UNITED STATES PATENT AND TRADEMARK OFFICE

APPLICATION NO.	FILING DATE	FIRST NAMED INVENTOR	ATTORNEY DOCKET NO.	CONFIRMATION NO.
10/757,923	01/14/2004	David W. Heeke	HDW102C	5124
32299	7590	10/27/2006		
DENISE M GLASSMEYER YOUNG & BASILE, P.C. 3001 W. BIG BEAVER RD., SUITE 624 TROY, MI 48084-2813			EXAMINER DIXON, ANNETTE FREDRICKA	
			ART UNIT	PAPER NUMBER
			3771

Office Action Summary

Exhibit A: Figure 1, Courtesy of Heeke et al. (5,562,106).

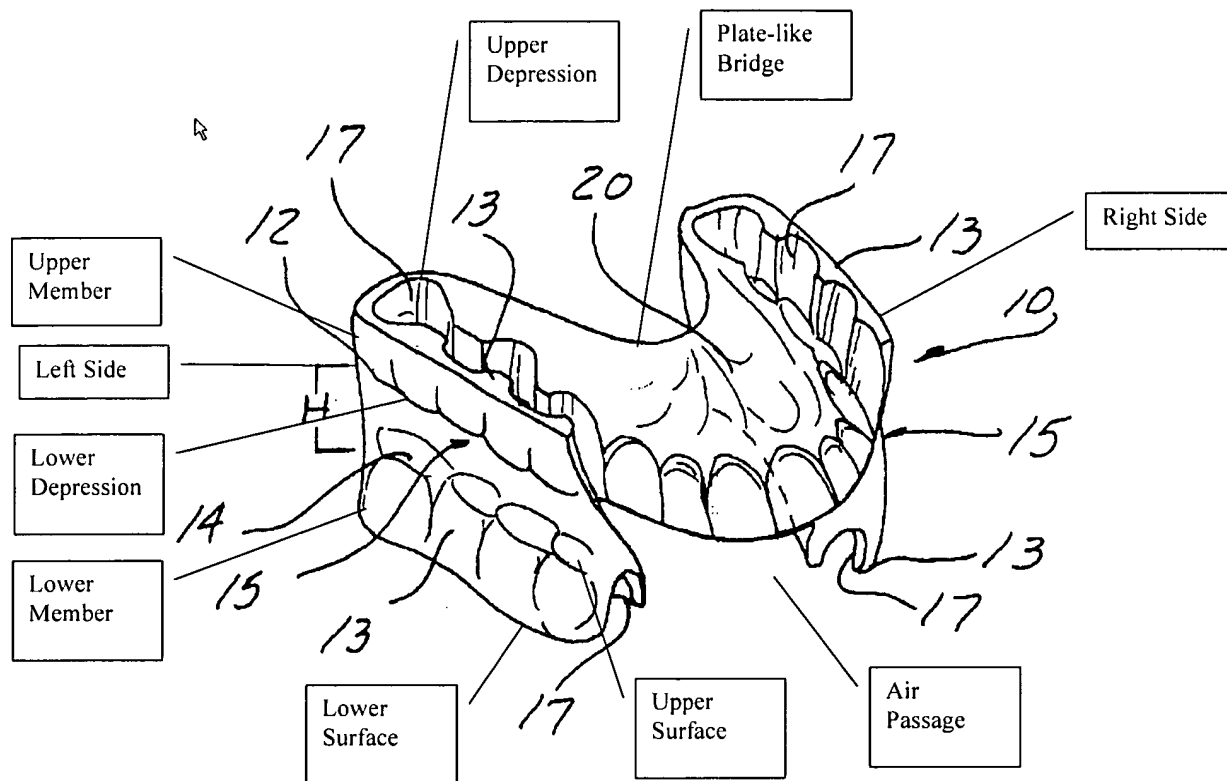
As to Claim 1, Heeke discloses an oral device removably insertable in the mouth of a user for facilitating breathing while sleeping comprising: an upper member (12), the upper member having upper and lower depressions and right and left sides corresponding to the location of at least back molars and second bicuspid configured to fit a mouth of a user (Column 5, Lines 4-8), said upper and lower depressions forming right and left biting surfaces wherein said biting surfaces are spaced at a height to force the mouth open the upper member further having a plate-like bridge (20) conforming to the back of the maxillary anterior and the upper plate of the mouth said bridge joining the biting surfaces; and a lower member (14) positioned in underlying spaced relationship relative to the plate-like bridge of the upper member, the lower member having a lateral member, the lateral member having an upper surface oriented toward the plate-like bridge, a lower surface opposed to the upper surface, and at least one curvilinear side surface extending from a frontal location to a terminal location proximate to the maxillary anterior of the user's mouth, the at least one side edge adapted to engage associated interiorly oriented regions of the upper member, the lower member positioned relative to the upper member so as to form an air passage for conveying introduced auxiliary pressured air from the mouth opening to the anterior of the mouth of the user. (Exhibit A). Regarding the curvilinear side surface limitation, inherently for a device to be placed inside the mouth and engaging the teeth the device must have an arcuate shape.

As to Claim 2, Heeke disclose a device wherein the lower member is in permanent contact with the upper member. (Figure 1).

As to Claim 3, Heeke discloses the upper member has a retentive portions extending over a super bulge of each of the back molars and second bicuspid. (Figure 1).

As to Claim 5, Heeke discloses a device wherein the plate-like bridge (20) conforms to the back of the maxillary anteriors and the upper palate of the mouth, said bridge joining the biting surfaces (Figure 1).
